PREVOST

SAFETY RECALL

SR23-14

DATE :	May 2023	SECTION :	06 ELECTRICAL
SUBJECT:	Power Cable Missing Grommet

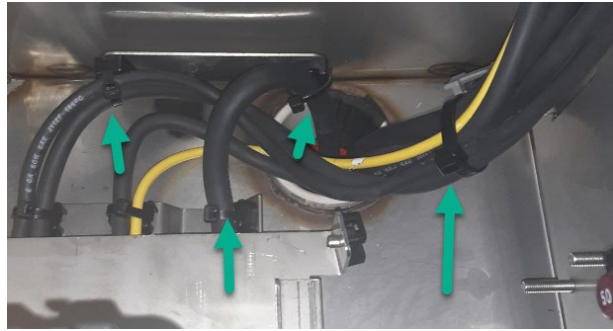
1. Locate the missing grommet location in the rear electrical compartment.
 - Open the vehicle curb side engine door.
 - Open the rear electrical compartment (next to the batteries).
 - In the compartment, the missing grommet must be installed in the cable pass through hole located at the top right corner of the compartment (hidden behind the battery equalizer).

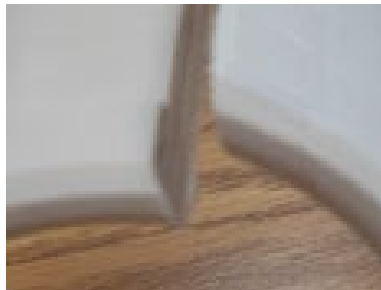
2. Cut all the cable ties holding the power cables passing through the hole.
3. Make sure that the cables insulation is not damaged.
 - If damage is noticed, replace the cable(s) before installing the grommet (do not repair power cable(s)).

4. Cut the supplied **069464** cable protector (grommet).
 - Slice the grommet with a slant cut to allow the insertion of the cables.

5. Install the grommet in the electrical compartment.

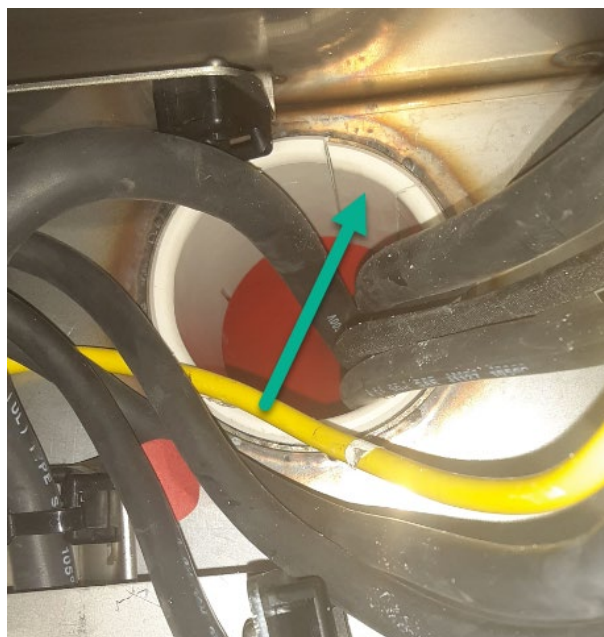
- Pass the cables one by one in the sliced cable protector.
- Slide the cable protector in the wall opening.
- Place the slanted cut at ± 75 deg from top (to clear the installed T-mount).

6. Solidify the cable protector installation.

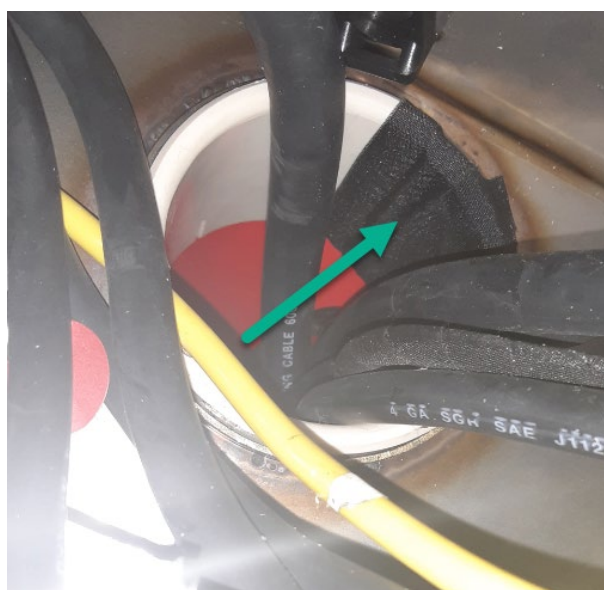
- Put a few drop of **680066** glue (or equivalent super glue) to “weld” the slanted cut of the cable protector.
- Add some **564099** cloth tape over the re-glued cut area as shown.

7. Secure the power cables.

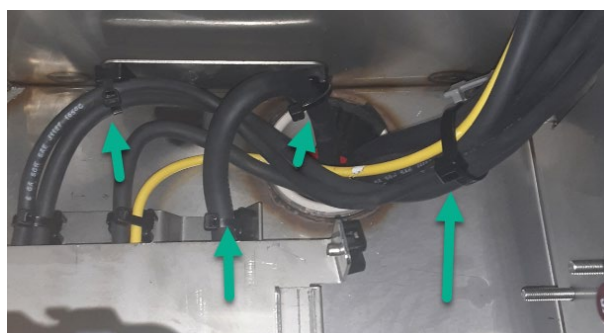
- Re-attach the power cables using the supplied **504016** & **504637** cable ties, make sure the cables are secure that there is no contact sharp edges.
